File: 2012-1002-Callout

Re: **Call-out Inspection Report** (Currently GP-21a- Erosion of w. ditch of N. Approach)
(Previously GP-21 Slide at previous twin culvert)
Hwy 719:02 at Henderson Creek Bridge
- Erosion distress along
Site (1) west ditch (riprap) down valley along North Approach to bridge
Site (2) east ditch (grassed) down valley along North Approach to bridge

Figure 1
Aerial Photo
Site Location Plan

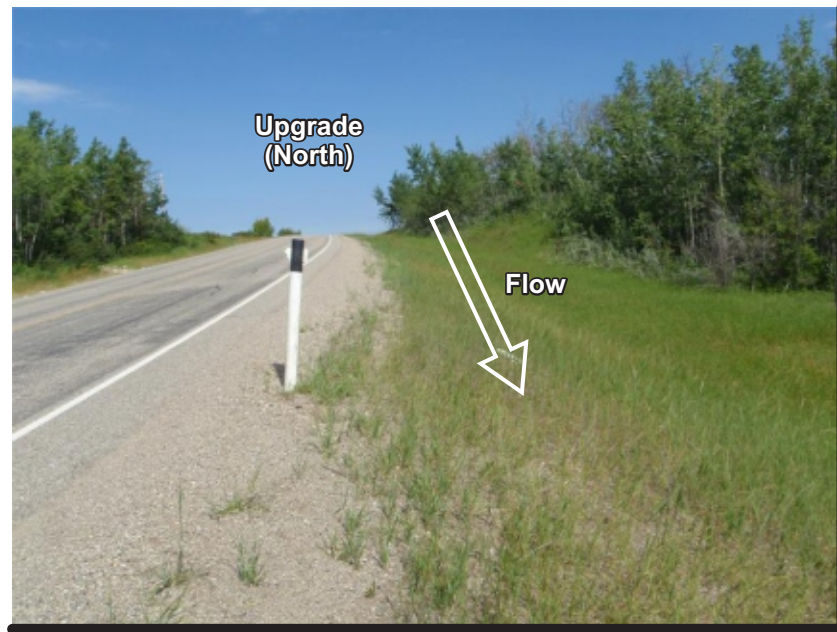
As indicated in Figure 1 (Site Location Plan), there were two ditches on opposite sides (west and east) of highway descending about 800m distance down the valley slope along its north approach to the new bridge. Along the west ditch, new riprap channel lining and some minor channel trimming-widening were evidently constructed along the west ditch during the 2009-2010 times of new bridge construction. It was apparent some design effort was exerted for such riprap ditch lining constructions (likely constructed as per design). Some areas of west ditch might have been widened to provide channel hydraulic section improvements. Along the opposite east ditch, the ditch was grassed and of narrower channel widths, likely of old vintage untouched ditch conditions (likely old times prior to 2010 bridge construction). In general, it was apparent that no substantial changes were made to the gradeline and channel sections along both ditches along this north downvalley approach (during the 2009-2010 time of new construction of bridge). Thus, the ditch gradeline down this north approach roadway should have remained unchanged overtime.

- As indicated in Figure 1. It was observed that a bundling of the culverts can be located at intersection at valley top (Hwy 719 junction with Twp 795 road) and there may be a likelihood (uncertainty) that excessive flows were converged from the culvert arrangements thereof. This needs to be further investigated.

Photo 1

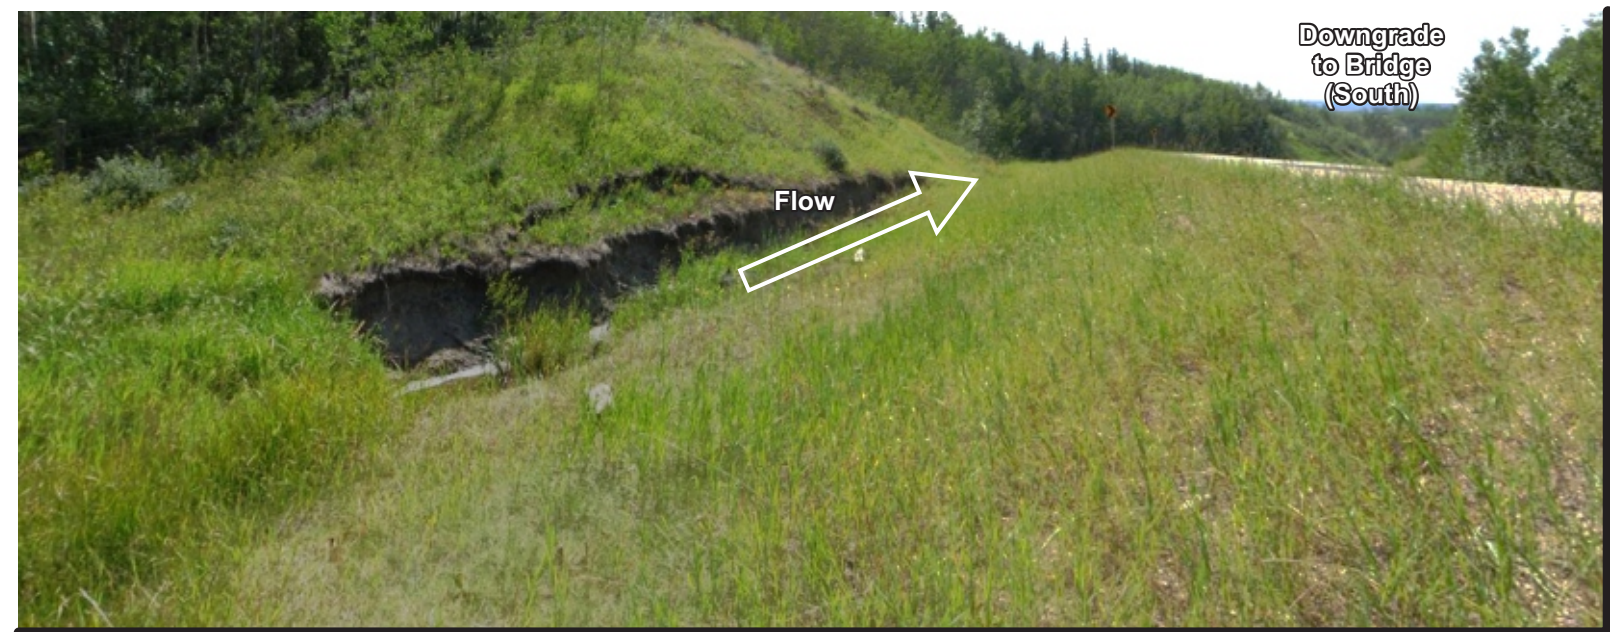
- Ditch not sustaining erosion distress and apparently less flow transmitting along this east ditch
- East (grassed) ditch going down the north slope
- Width bottom grassed ditch is of trapezoidal width at top portion of valley slope

Photo 3a

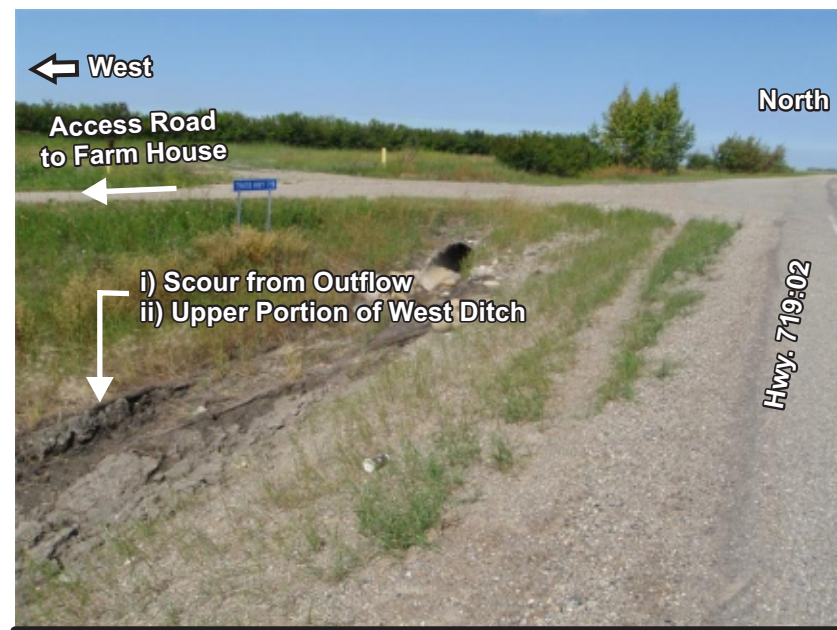
- Apparently the damming up waters by Twp 795 Resource road embankment may have converged upland waters to flow into Hwy 719 west ditch
- Need to check any cross drainage culvert constructed along Twp 795 R. road for equalizing flows on its both sides (north to south)
